Minor Amendment to Site Plan

**RE: JUSTIFICATION FOR MINOR SITE PLAN AMENDMENT
PAN AMERICAN FWY, ALBUQUERUQUE, NM
LEGAL DESCRIPTION: LT 1 PLAT OF LTS 1, 2, 3 & 4 SRCC
ALBUQUERQUE CARPENTERS TRAINING CENTER
ZONE ATLAS PAGE – G-16-Z**

Tierra West, LLC, on behalf of our client, Southwest Regional Council of Carpenters requests approval of minor site plan amendment for a 6.36 acre site located in the Carpenters Training Center. The property is located at Pan American Fwy and Vassar Dr. The lot is currently zoned as Non-residential – Light Manufacturing (NR-LM) per the Integrated Development Ordinance.

MASTER SITE PLAN

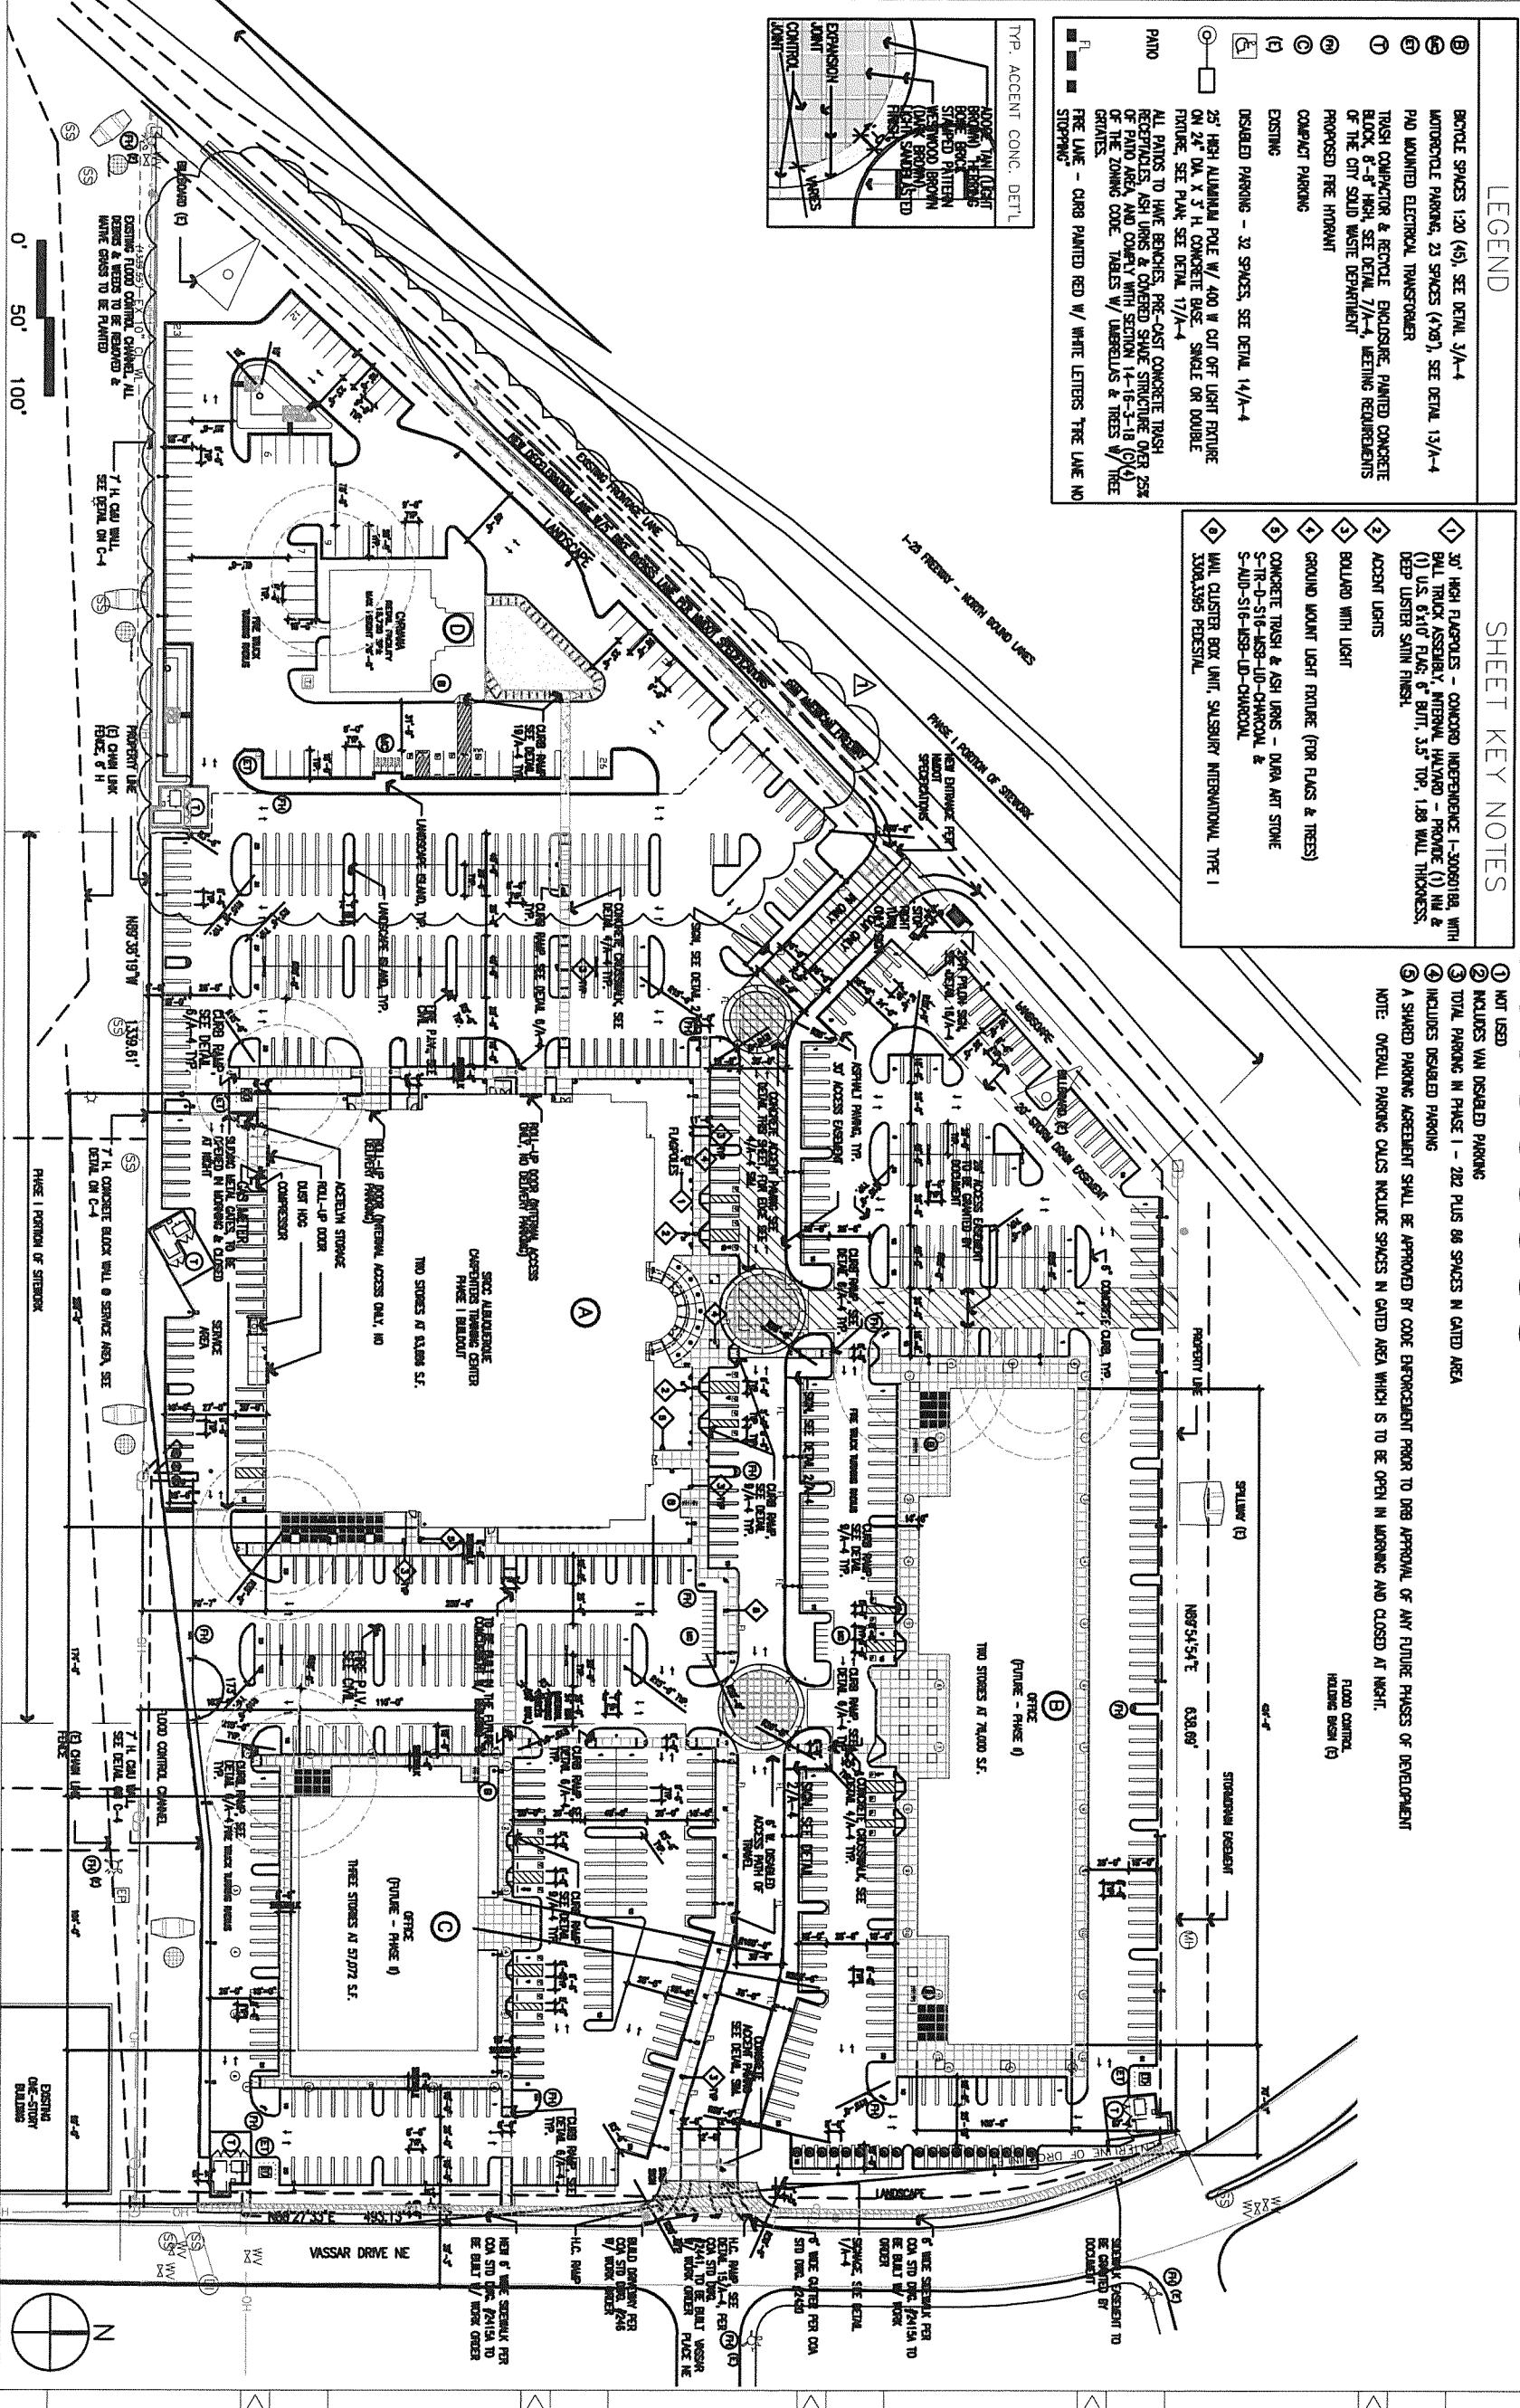
The only change is to provide a wider access aisle through Tract 1 (Carpenters Training Center) to Tract 4 (Carvana) to allow for vehicle transport trucks to deliver vehicles to Carvana. This drive aisle would eliminate 8 parking spaces on the Carpenters Training Center. As these parcels have shared parking as out lined in the Approved Overall Site Plan there is still enough parking to meet IDO requirements.
